## ADDENDUM No. 4

ITB No. 4665

### Wheeler Facility Pond Dredging

**Bids Due: March 30, 2021 at 10:00 A.M. (Local Time)**

**TYPICAL SHRUB PLUG LAYOUT PLAN**  
 N.T.S.

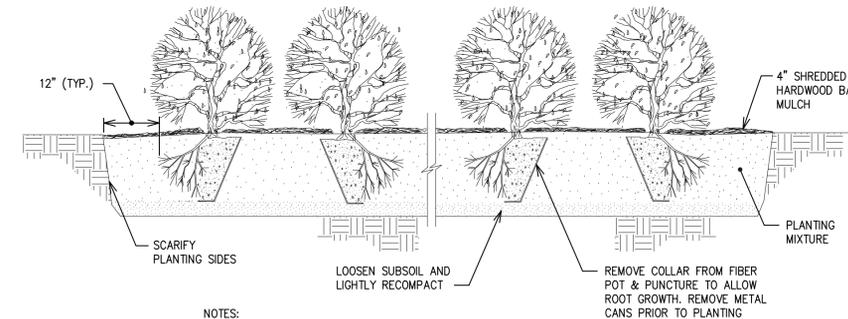
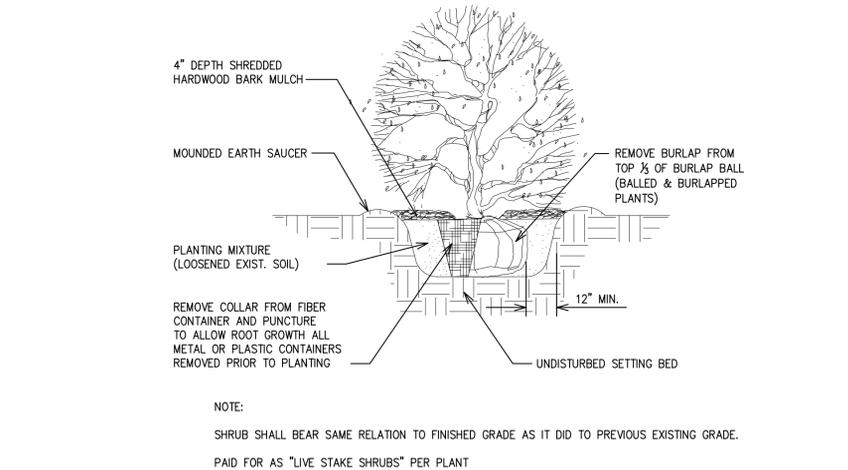
Question 11: There is no item for hardwood mulch, but it is shown on the details for the planting beds. Do we provide and install that material as part of the 708 live stake shrubs to be installed?

Answer 11: Yes, the hardwood mulch is to be part of the overall cost of the shrub and installation.

**SOIL EROSION &  
 SEDIMENT CONTROL  
 DETAILS**

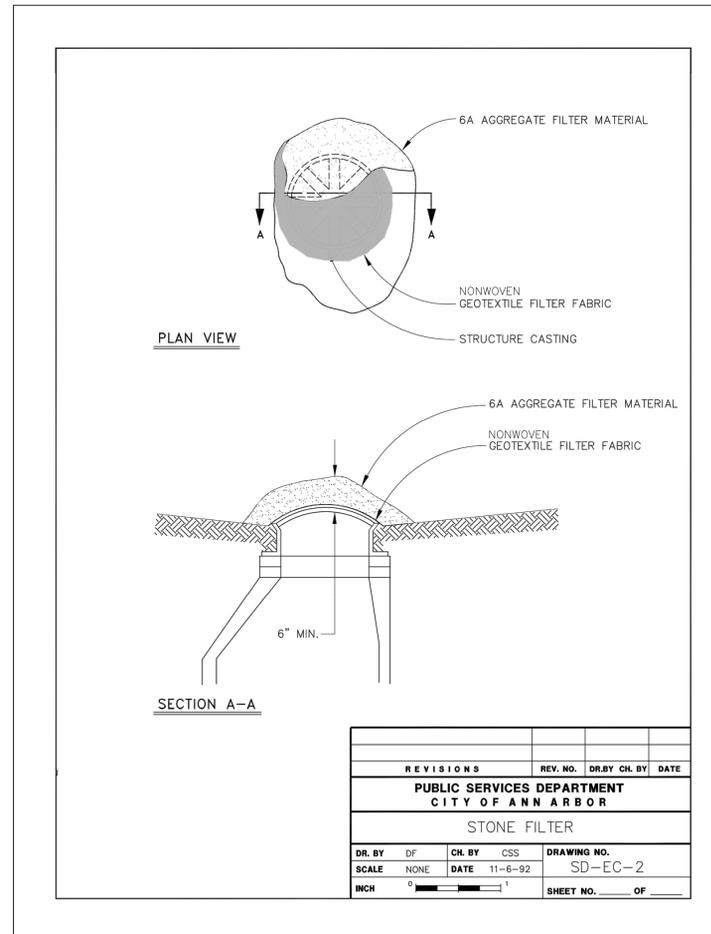
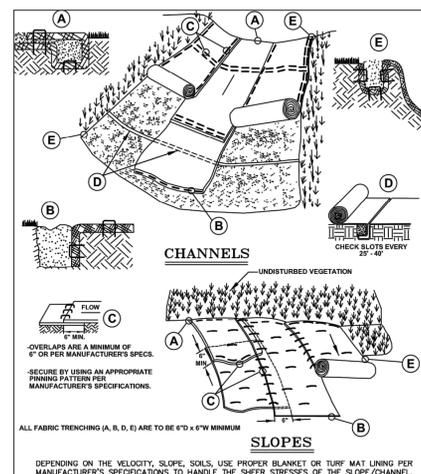
- Answer 4: Soil samples have been taken and can be provided to the successful contractor prior to start of construction.
- Question 5a: Can silt fence be used in lieu of the silt sock product?

- Answer 5a: Yes
- Question 5b: If silt sock is required, is a single row acceptable? The detail shows installations where the silt sock is stacked and requires +/- 3 "socks" per LF of installation. Please advise.

- Answer 5b: Yes
- Question 6: Do you really want 6' chain link fence as indicated in the plans and specifications? As this is a gated facility, this seems like overkill. Please advise.

**OVERALL SITE  
 PLAN**

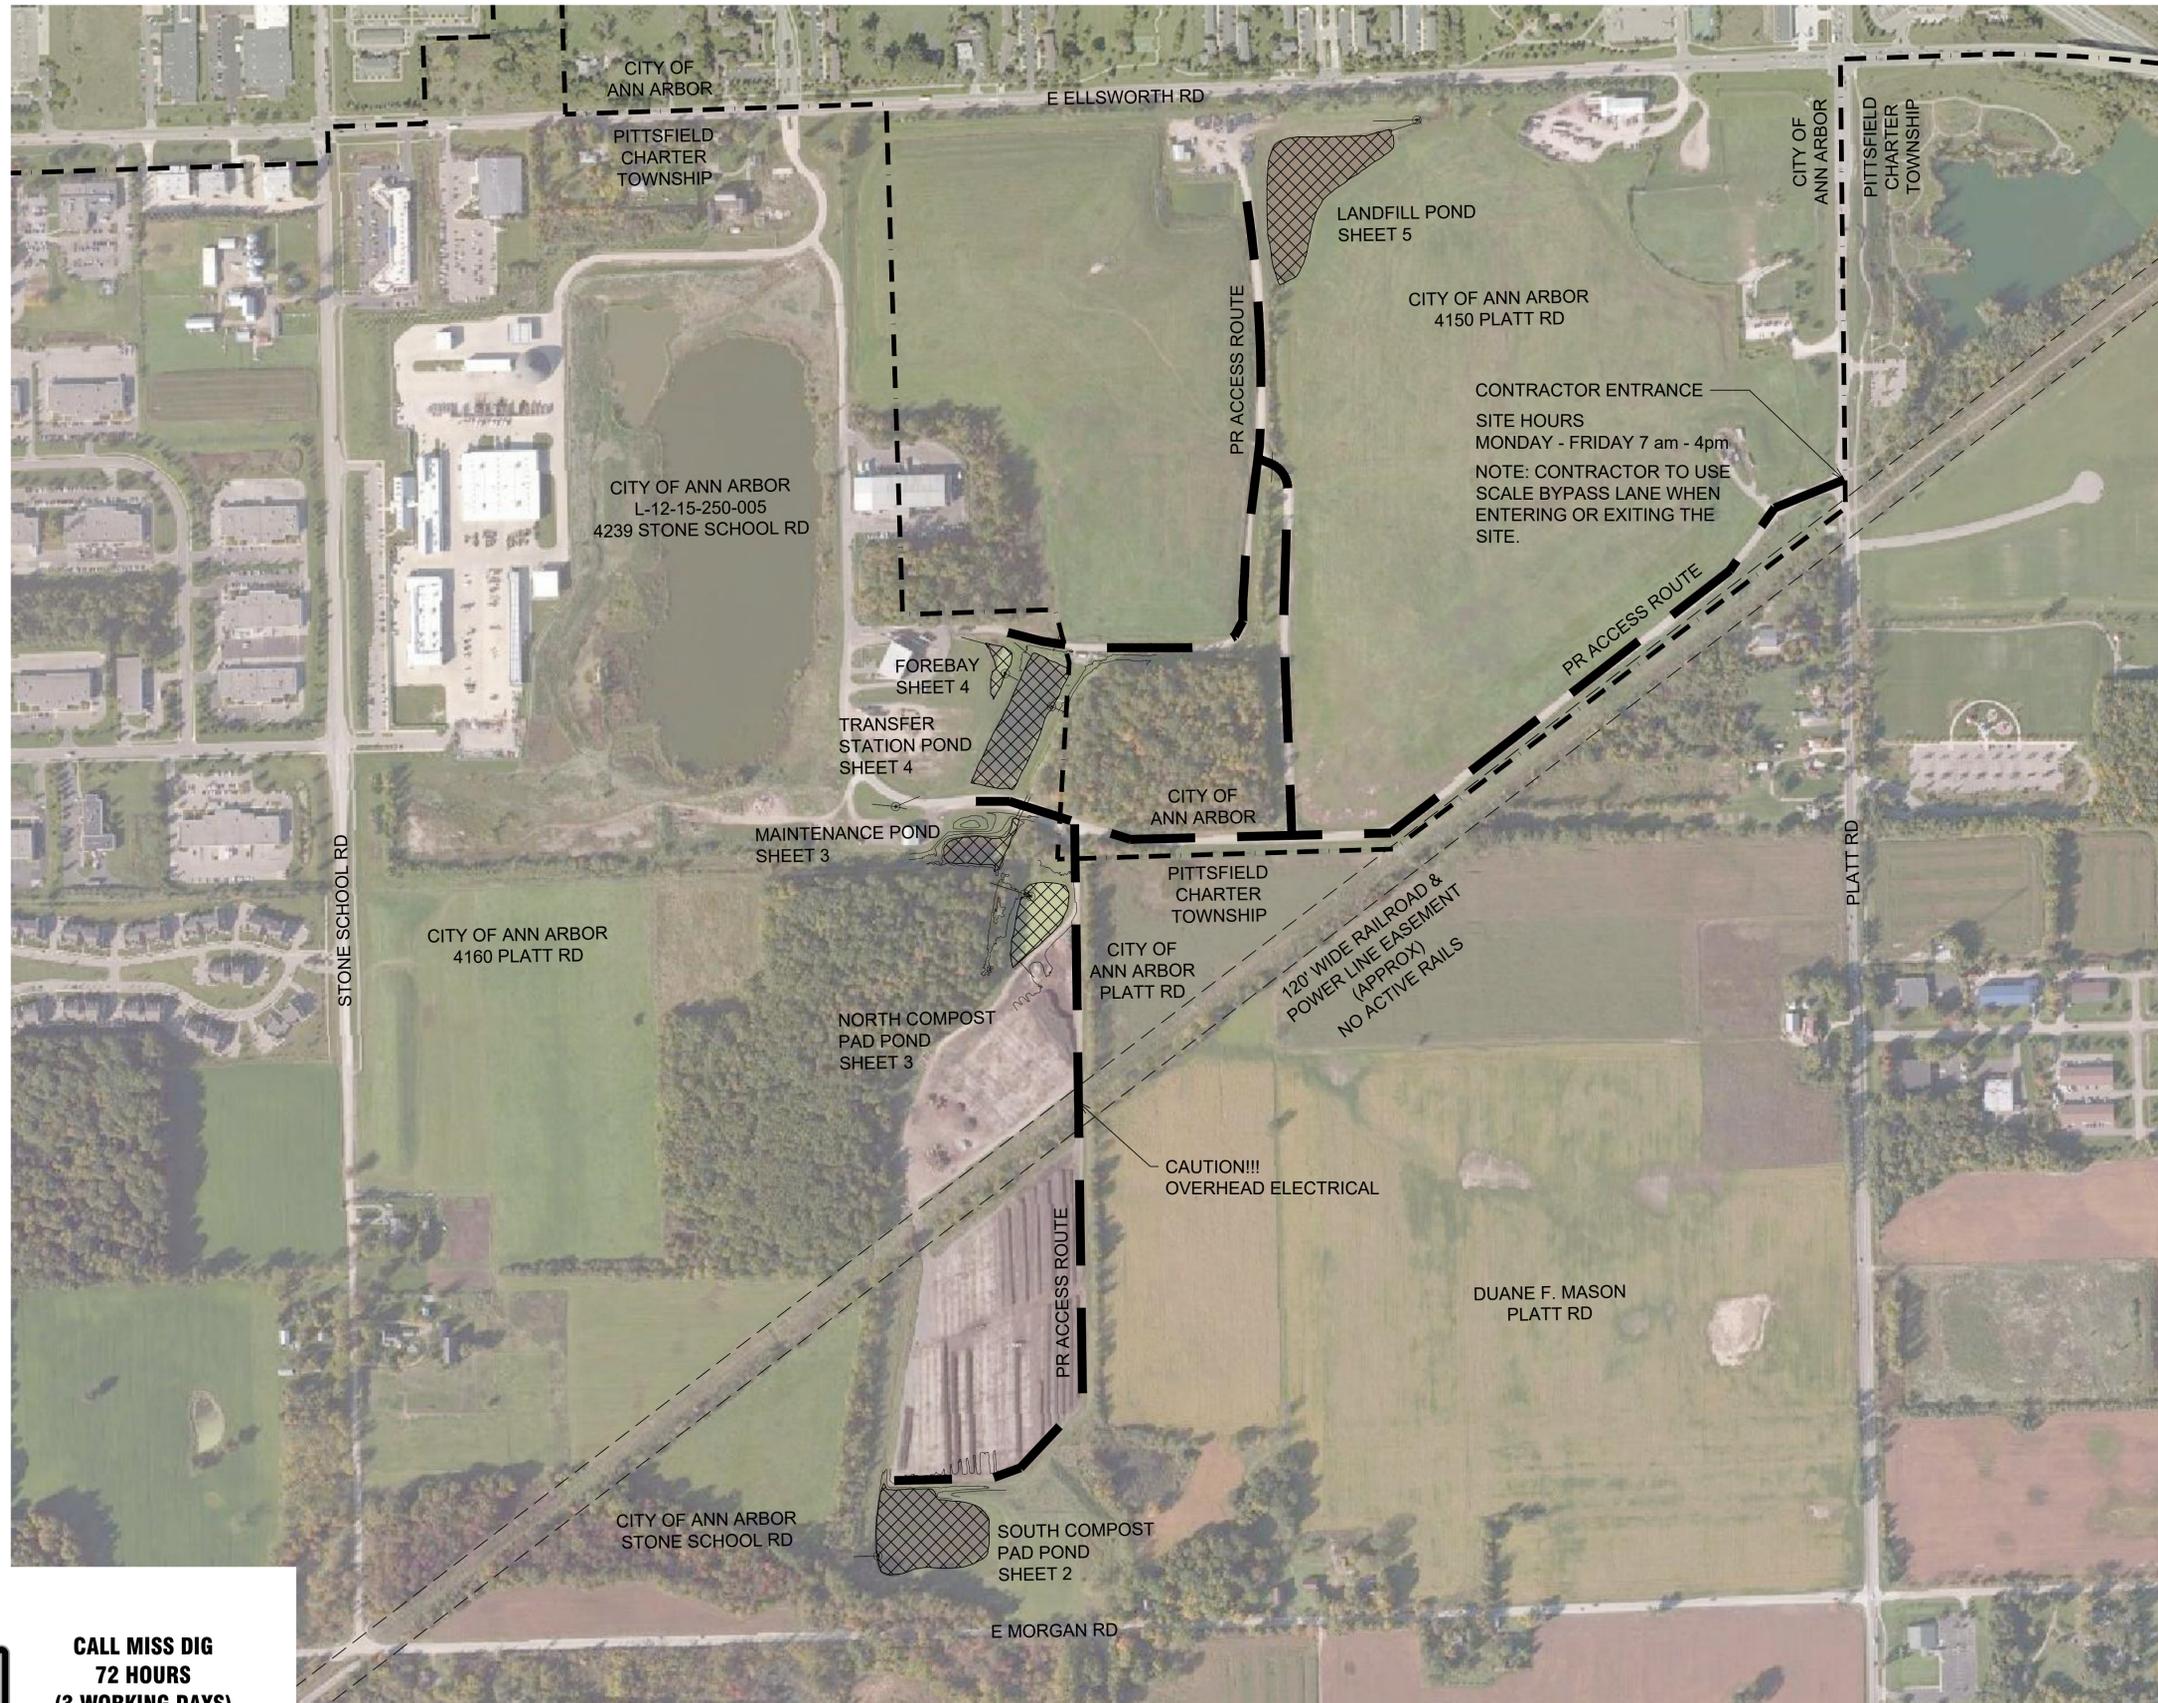
Question 9: Once we leave the Wheeler Facility are there certain roads we have to follow?

Answer 9: Sheet 1 of the plans shows the access route in and out of the Wheeler Facility. More detailed information of proposed changes can be discussed with the successful bidder at the time of the preconstruction meeting.
